# Metro Planning Commission Meeting of 12/8/05

## REQUESTED CHANGES TO THE "STRUCTURE" AND "DETAILED" LAND USE POLICIES IN THE NORTH NASHVILLE COMMUNITY PLAN: 2002 UPDATE

**To amend the ‘Structure Plan’ land use policy and Appendix E-17 of *The Plan for Subarea 8-the North Nashville Community: 2002 Update***

#### AREA 1:

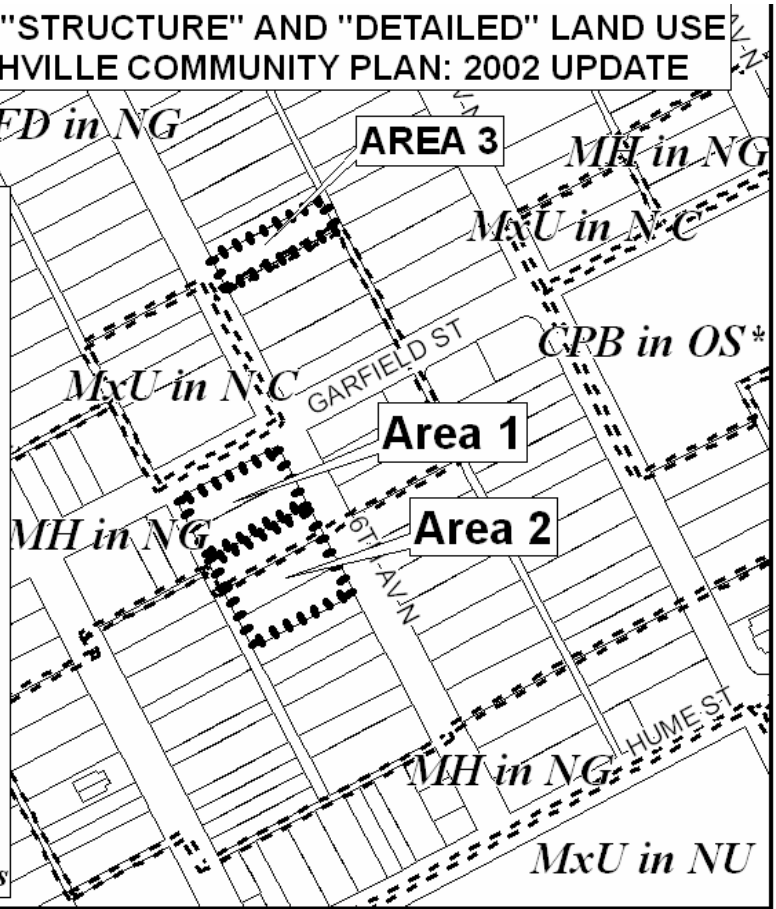
- 1) Change "Structure Plan" policy from "NG" (Neighborhood General) to "N C" (Neighborhood Center) and
- 2) Change "Detailed Land Use Plan" policy in Appendix E-17 from "MH" (Mixed Housing) to "MxU" (Mixed Use)

Exhibit 1. Slopes and proposed townhome units, access points, and open space area

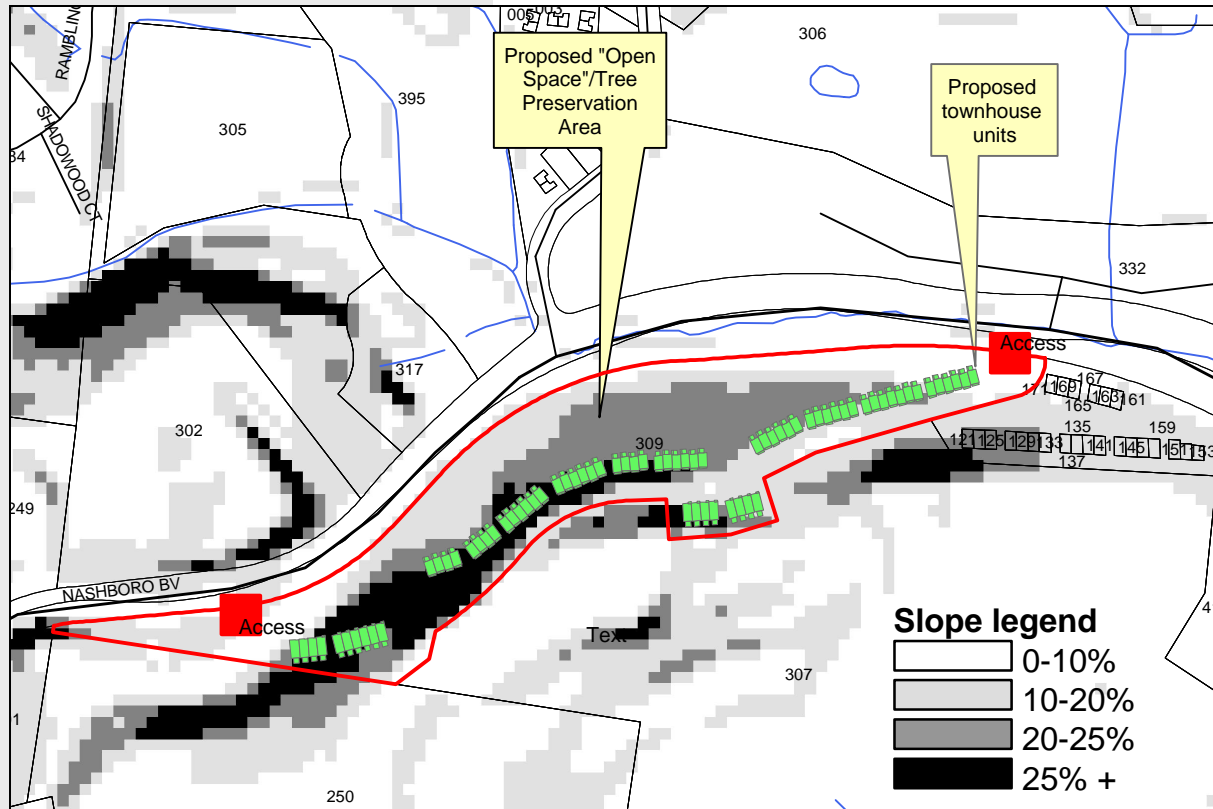
The area where existing mature trees are to be preserved has slopes between zero and 20 percent, while the area proposed to be partially graded has slopes ranging from 10 to over 25 percent (see Exhibit 1). Nevertheless, because the preliminarily approved PUD does *permit* townhouse development on slopes over 20 and 25 percent, a certain degree of grading looms imminently within this site’s panorama. The applicant has worked with Planning staff, however, to minimize excessive grading beyond the area to be partially disturbed for townhome development on this final PUD.
